REMARKS

This Preliminary Amendment is to clarify portions of the Application, including the Specification and Claims, to add a new claim, to add a replacement Abstract of the Disclosure, and to amend the Drawings. Also included are a Substitute Specification, a marked-up copy of the Substitute Specification showing the changes made and an English-translation of the International Application. No new matter has been added.

~~SOLID BOWL SCREW CENTRIFUGE COMPRISING A SCRAPING BLADE~~  
~~CENTRIPETAL PUMP~~

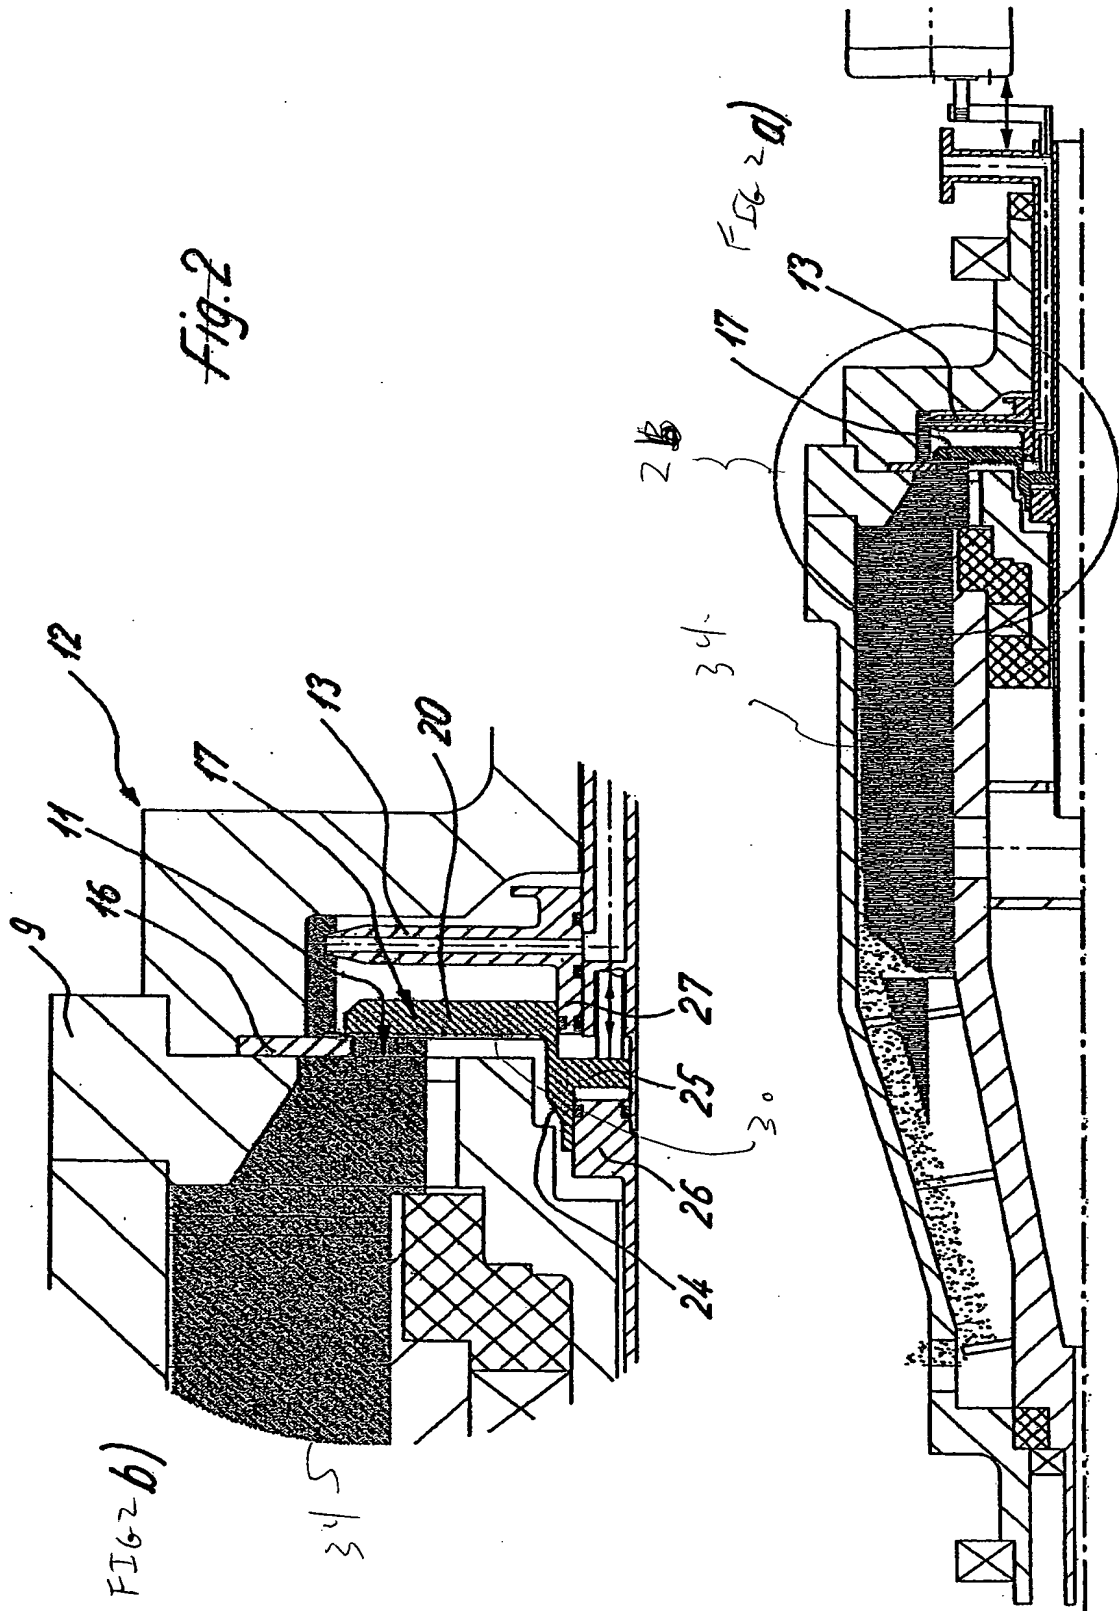
**[25][00024]** ~~Figure 2a is a sectional view of the solid bowl screw centrifuge of Figure 1 in a~~  
~~first operating condition[[;]].~~

~~26~~[00025] \_\_\_\_\_ Figure 2b is a view of an enlargement of a cutout of ~~designated as 2b in Figure~~  
2a~~[[;]]~~.

~~27~~[00026] \_\_\_\_\_ Figure 3a is a sectional view of the solid bowl screw centrifuge of Figure 1 in a  
second operating condition~~[[;]]~~.

~~28~~[00027] \_\_\_\_\_ Figure 3b is a view of an enlargement of cutout of ~~designated as 3b in Figure~~  
3a~~[[;]]~~.

**[40][00039]** On the example of Figure 2b shows a relatively narrow gap (Figure 2) ~~or 30~~ and Figure 3 shows a relatively large gap (Figure 3) ~~32~~ between the throttle disk 17 and discharge openings 11; ~~[-]~~. Figures 2 and 3 illustrate the ~~shows an~~ effect of the throttle disk 17. ~~In each case, the~~ An actual discharge takes place by means of the centripetal pump 13; ~~whereas.~~ Whereas, by means of the throttle disk 17, the discharge quantity and the pool depth in the drum ~~are~~ can be regulated. A special advantage is also the A combination of the centripetal pump 13, the throttle disk 17 and the baffle plate 6 on the screw which, ~~interacting~~ 3 interacts with the throttle disk ~~[-]~~ 17 and ~~permit~~ permits an a particularly advantageous adjustment of the conditions. Thus, for example, by means of the throttle disk 17, ~~another~~ a condition with a so-called shallow pool, that is, with a low pool depth, can be used in the an operation until a sufficient bed formation of solids has taken place in the drum 2 in order to then increase the pool depth to the ~~maximally a~~ maximum possible value. Thus, not only the an overflow level is adjusted by means of the throttling device disk 17 but the pool depth is also influenced by throttling the discharge.

*Fig. 4*  
PRIOR ART

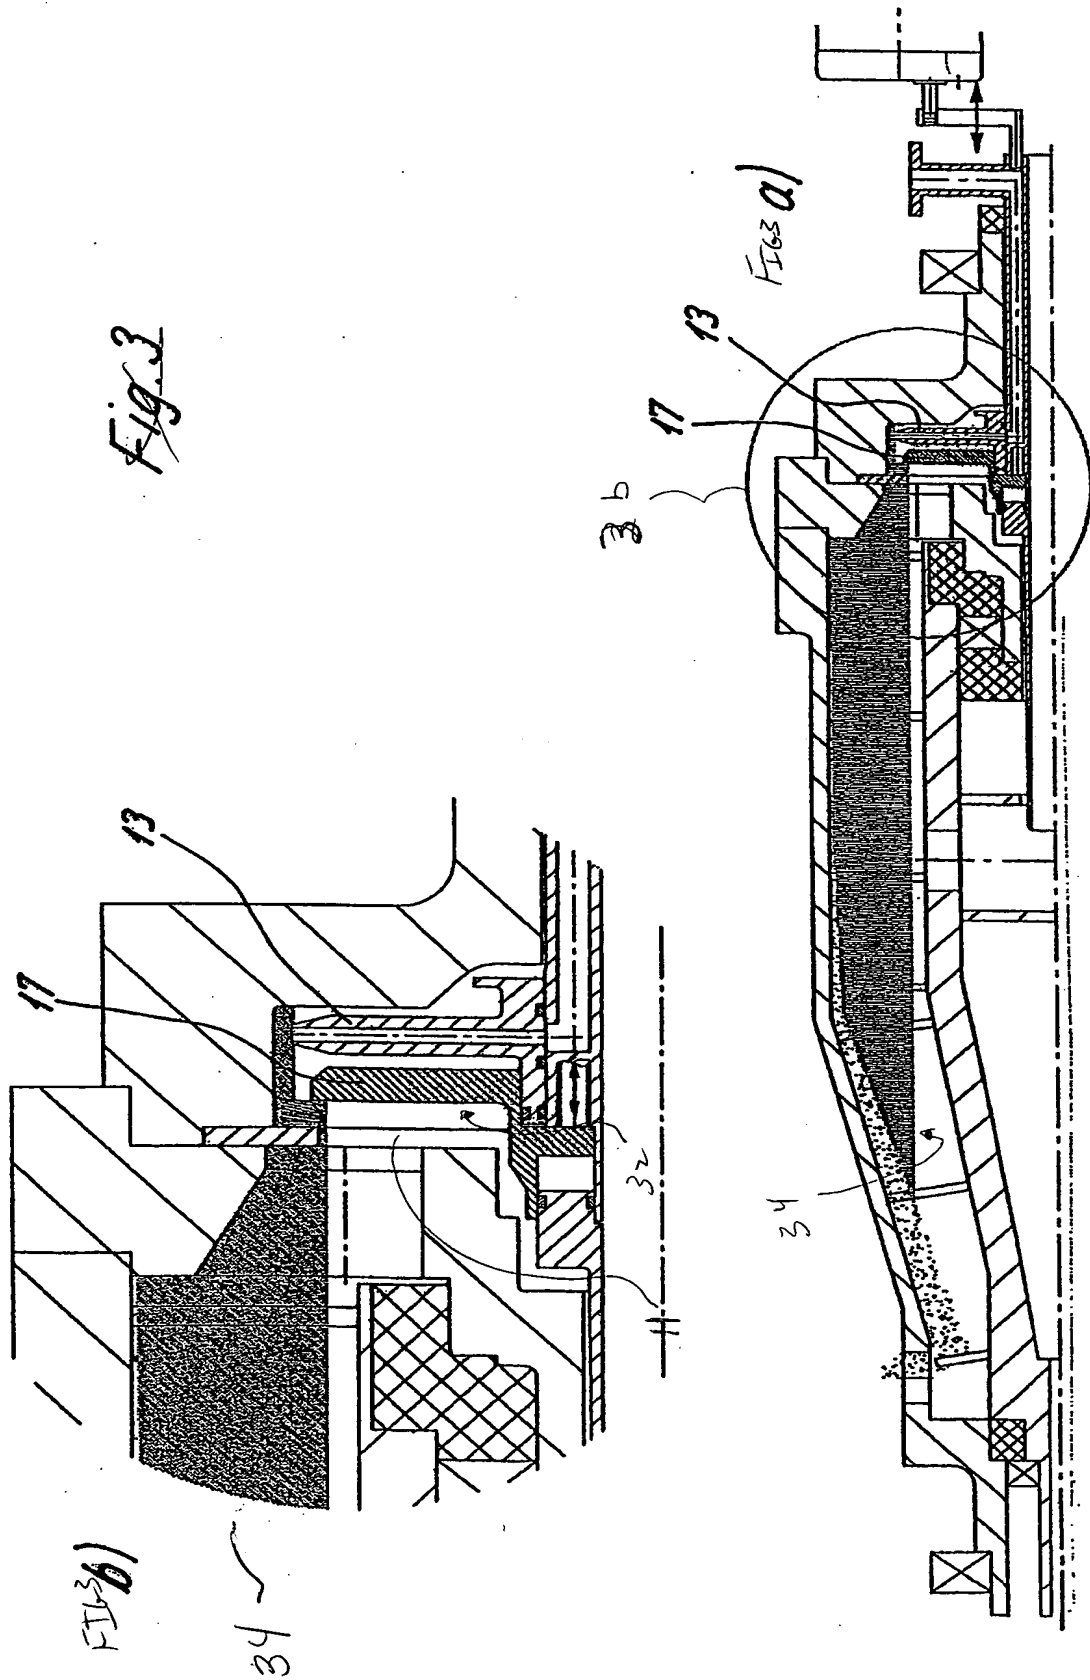
~~29~~[00028] \_\_\_\_\_ Figure 4 is a sectional view of a drum of a solid bowl screw centrifuge according  
to the state of the art~~prior art~~.

**[00040]** Figure 4 shows a solid bowl screw centrifuge according to the state of the art, where no throttle disk 17 is arranged in the centripetal chamber section.
